S/D 90-13 - EAST SUBSTATION ADDITION

Re: S/D 90-13 EAST SUBSTATION ADDITION

EAST SUBSTATION ADDITION

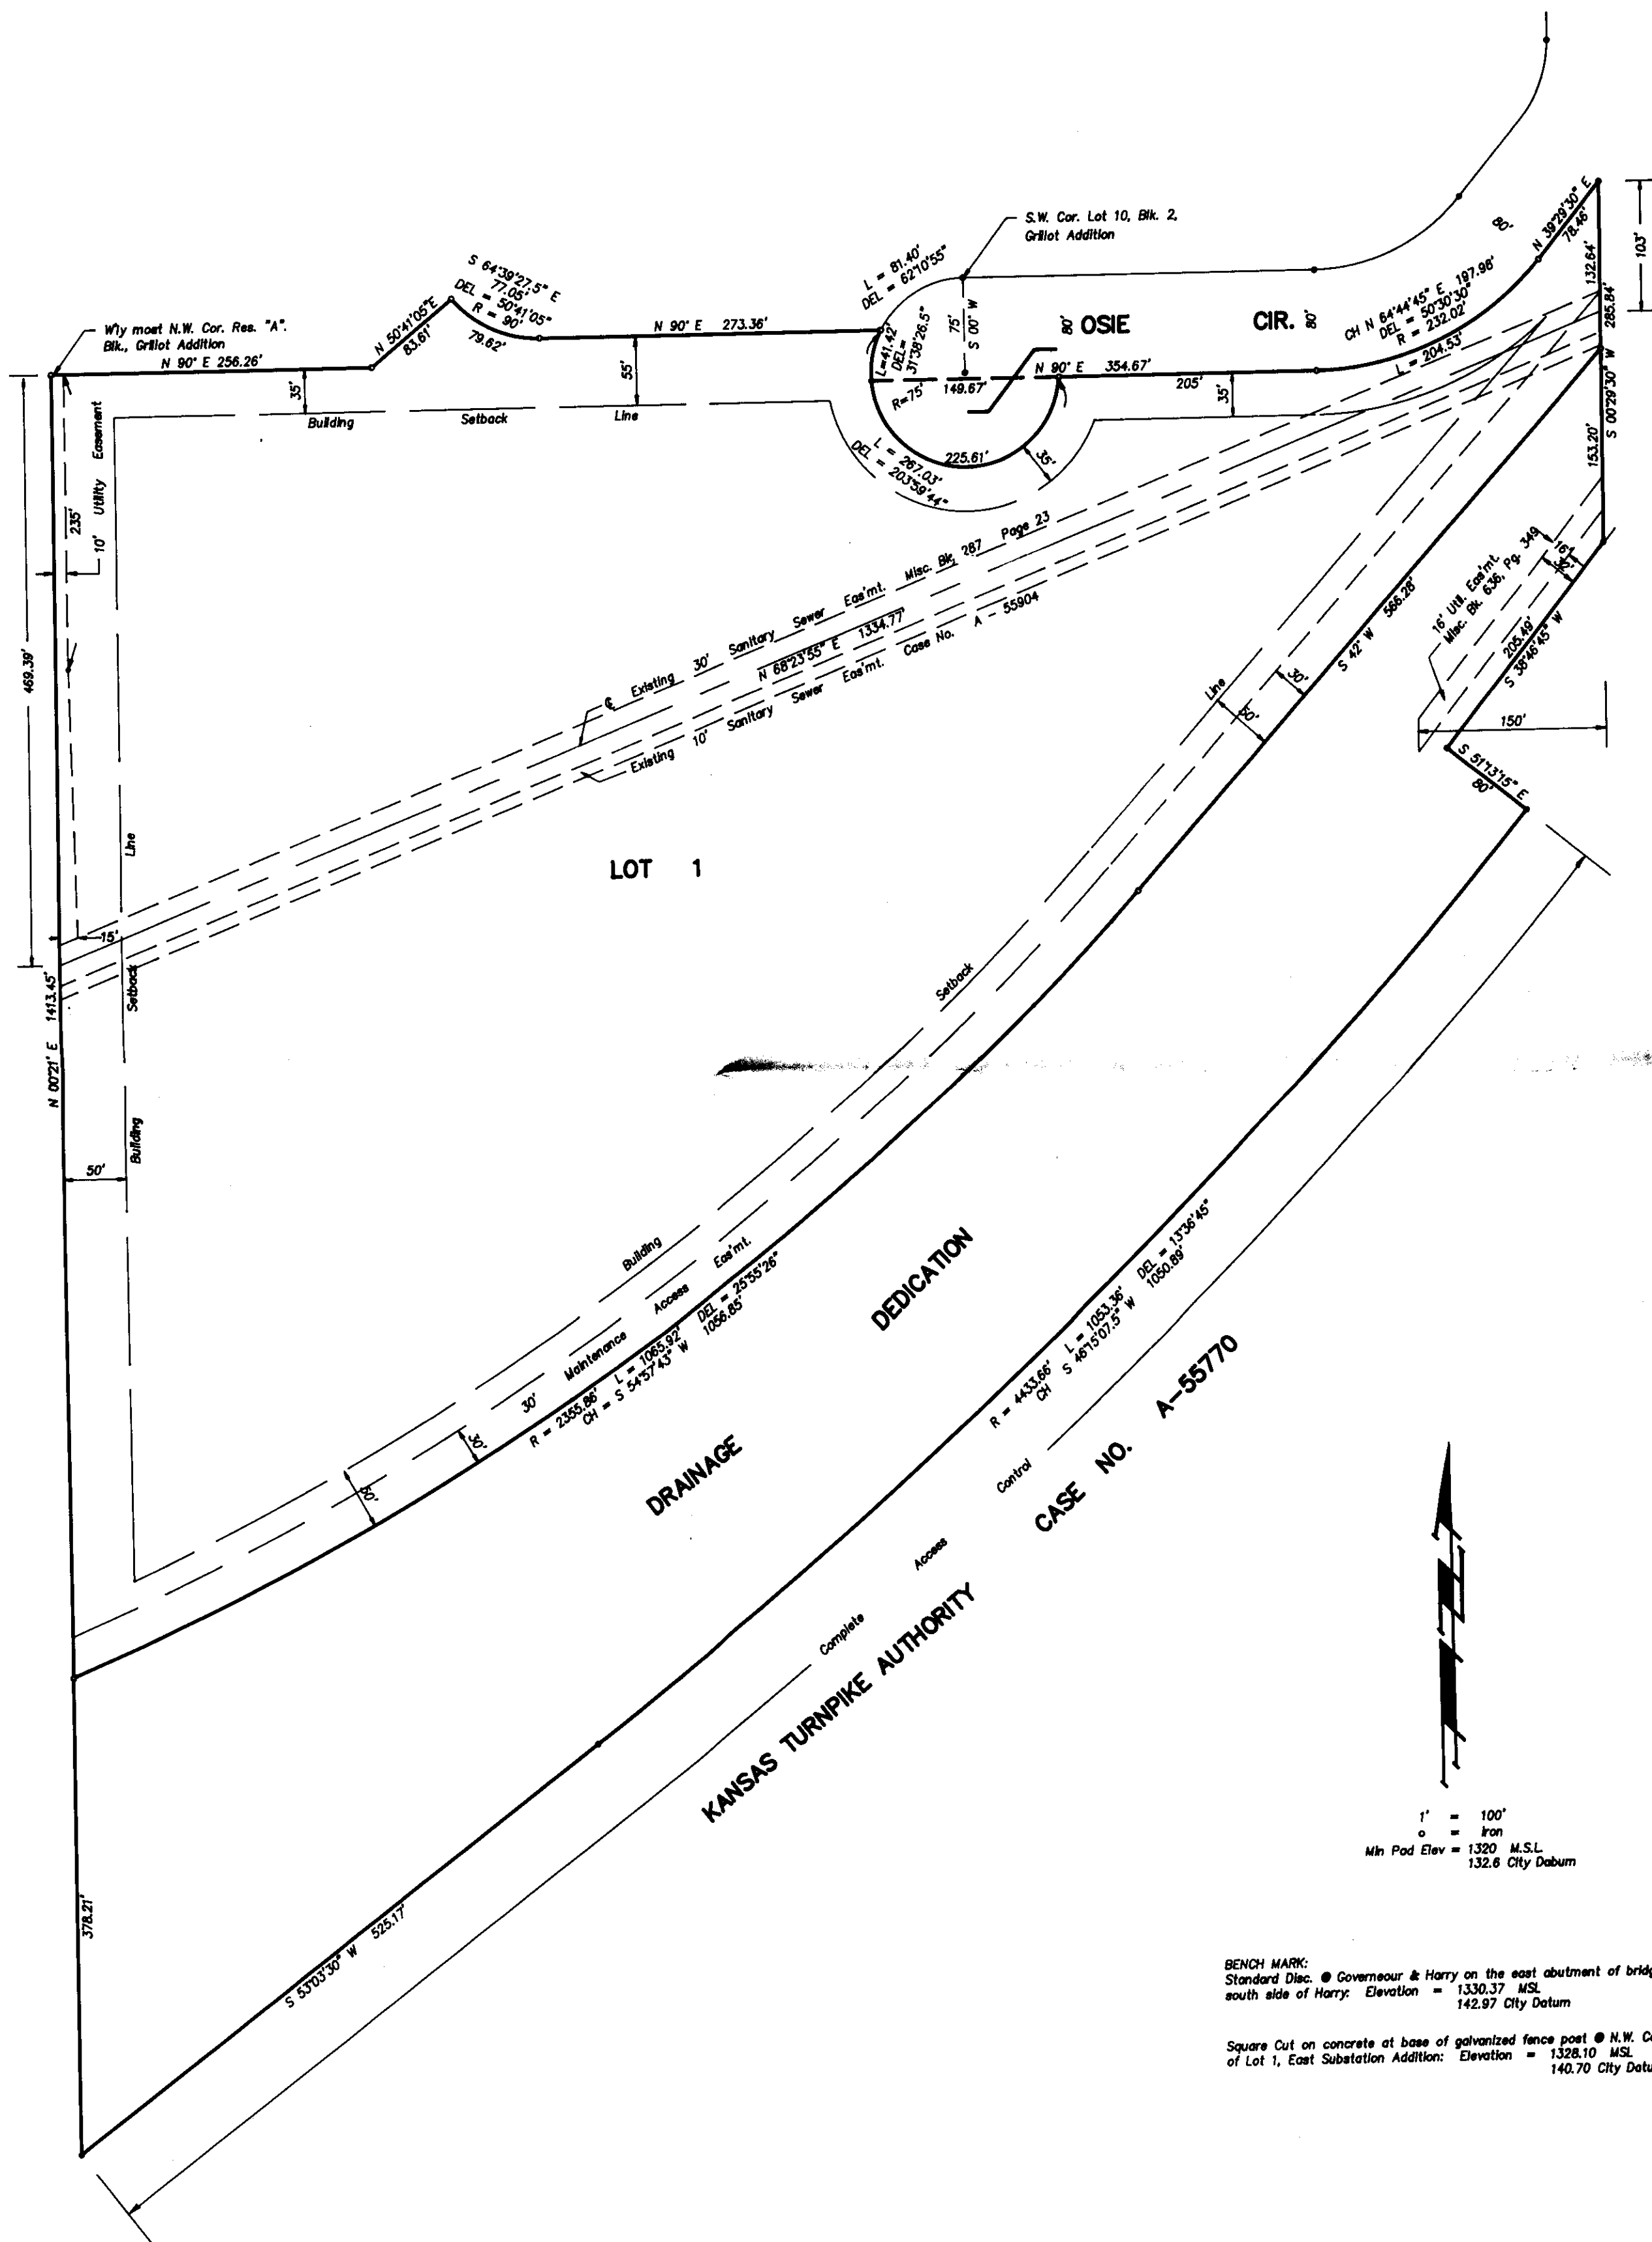
- A. The applicant shall provide for any drainage improvements required by the platting of this property. These guarantees may be included with the paving guarantees.

- B. The applicant shall provide for the paving of the interior street (Osie/Gouverneour from Harry) and the cul-de-sac required for the proper termination of Osie Circle.

- D. Since this plat is proposing the vacation of a portion of the south half of Osie, abutting property owners to the north should also consent in the vacation. The applicant shall therefore attempt to get the owners of Lot 1, Grillot 3rd and lots 11 and 12, Grillot Addition to sign a separate vacation application for the north half of Osie. As part of the vacation, the owner of Lot 12, who is also the owner of Lot 2, Grillot Addition should be required to submit a covenant requiring that these two lots not be sold separately. The covenant is necessary since Lot 12 will no longer have access to a public street. If such a covenant cannot be obtained the City by separate instrument should establish an access easement to the benefit of Lot 12, Grillot Addition which would allow access to Osie Circle.

- E. Since the tie point for this plat is referenced to a previously platted lot corner, the engineer's text shall reference the quarter section in which the plat is located. Section 5-402(D)(3).

- G. The final plat tracing shall indicate utility easements for the planned storm water sewer and existing sanitary sewer along this plat's east line. Also, the plat tracing shall indicate the utility easements requested by Southwestern Bell Telephone and indicated on the enclosed marked copy of the plat.
